REQUEST FOR ACTION

CDR - FY '92 MODIFICATIONS TO THE 16 FOOT TRANSONIC TUNNEL (1146) 12-06-91	Action Item No. 3
Requested By: Charles Mercer	Approved:

MODIFICATIONS TO 16-FOOT TRANSONIC TUNNEL (1146)
ENTRANCE ARCHITECTURAL STUDY

BLDG. 1146
EAST ELEVATION

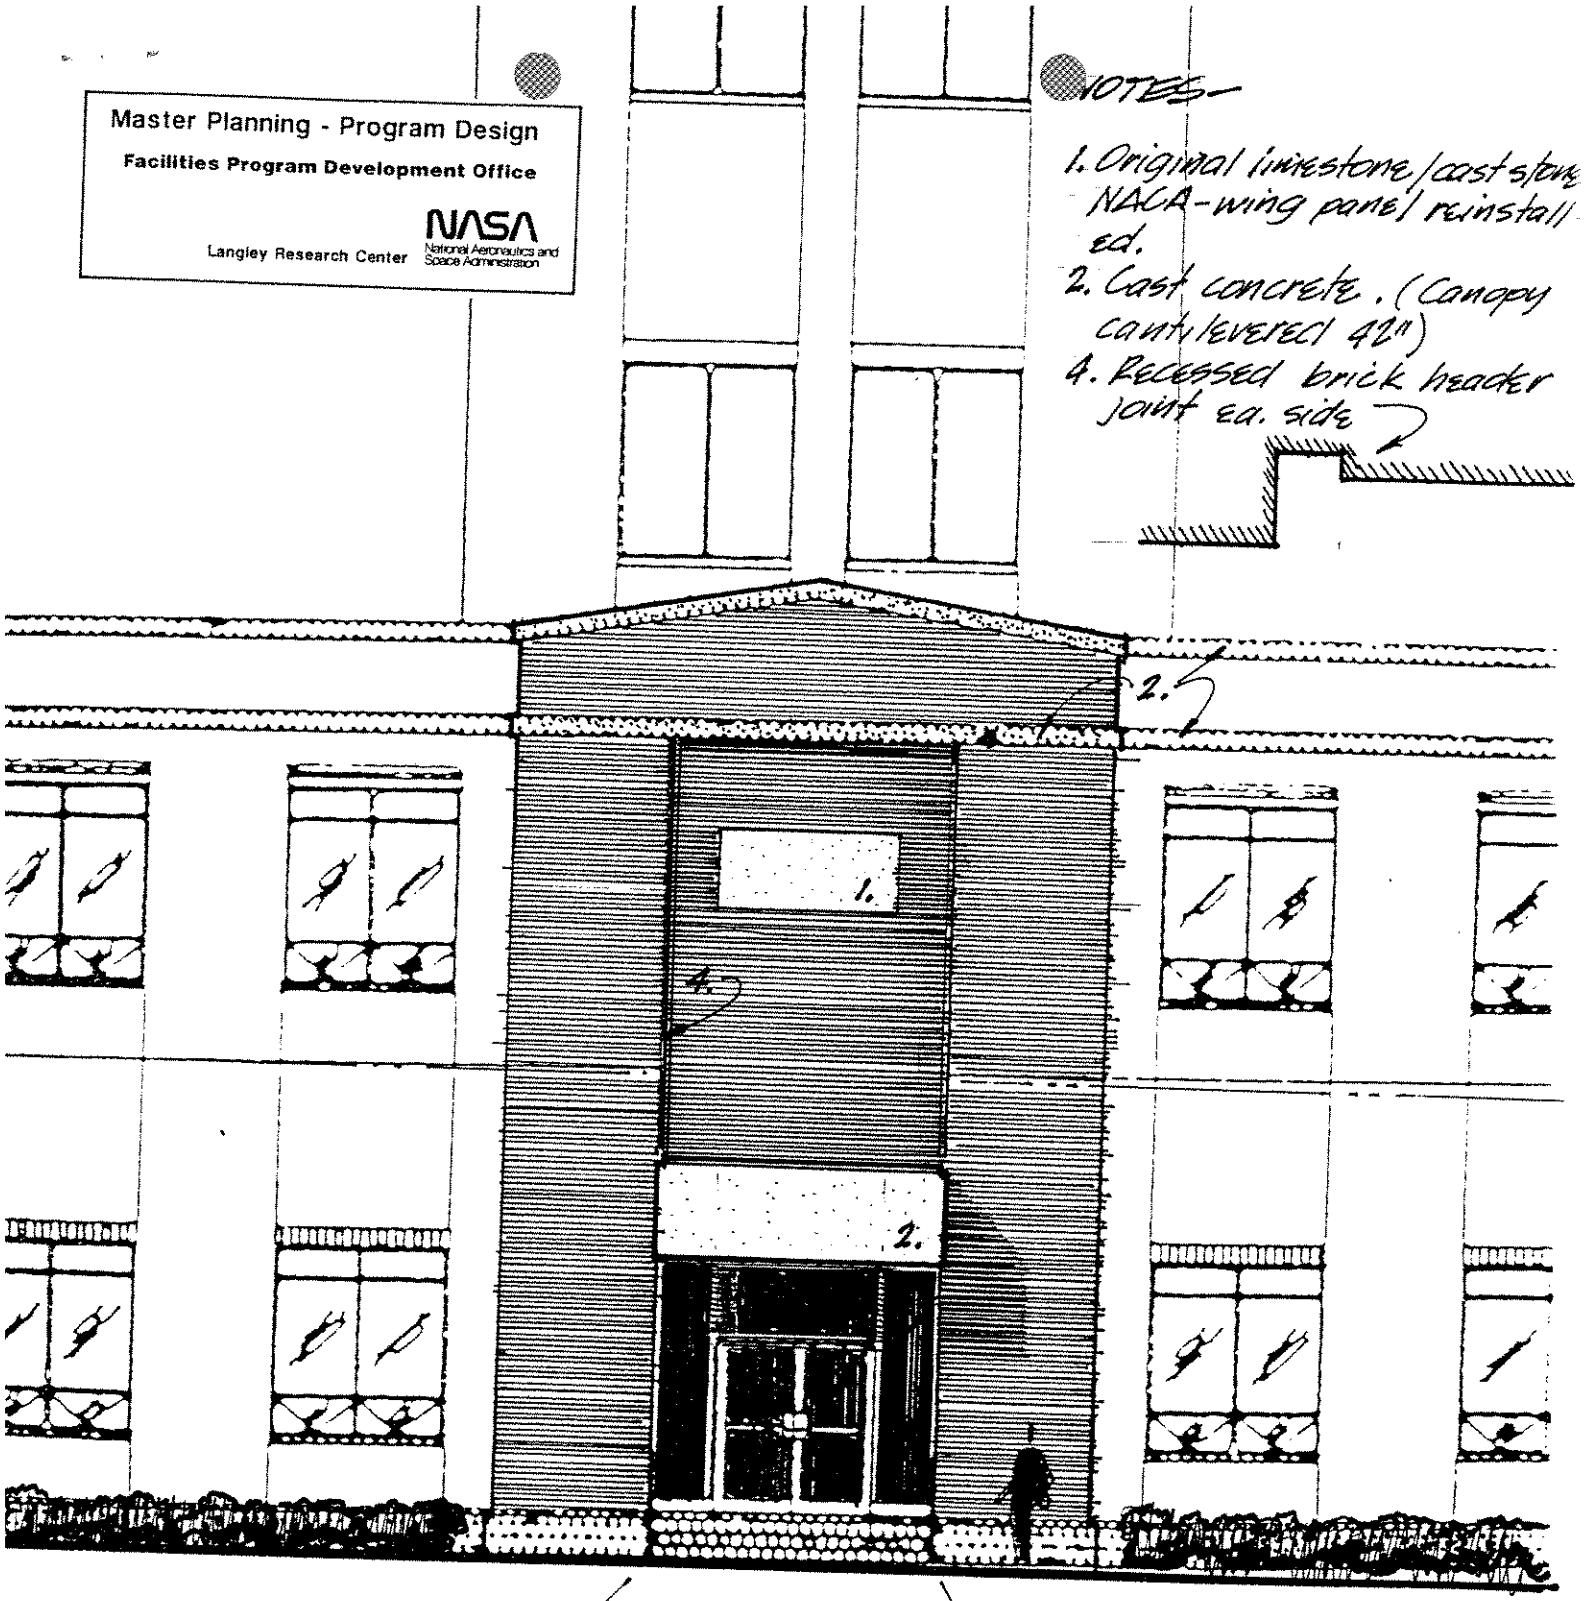
I have not yet received the official action item ~~[illegible]~~, but have ~~made~~ made a study of the entrance under the mod. project (1146). Please furnish your reaction. (Need responses from those copied as well)

If under the LaRC unified address system, certain buildings are eventually designated for displayed names — and if 16-foot is included — the canopy could serve as signage panel.

Do not recommend meatball.

In false glass area above front door install old NACA wing and new NASA "meatball" to building contour.

Recommendation: Carefully recover the original NACA-wing "stone" panel in existing facade and reinstall in running bond brick entrance wall. Provide projected canopy of struct'l steel and clipped on cast concrete face paneling to match coping, belt course, etc. Provide interior roof drainage.

1. Original limestone/cast stone NACA-wing panel reinstalled.
2. Cast concrete. (Canopy cantilevered 42")
4. Recessed brick header joint ea. side
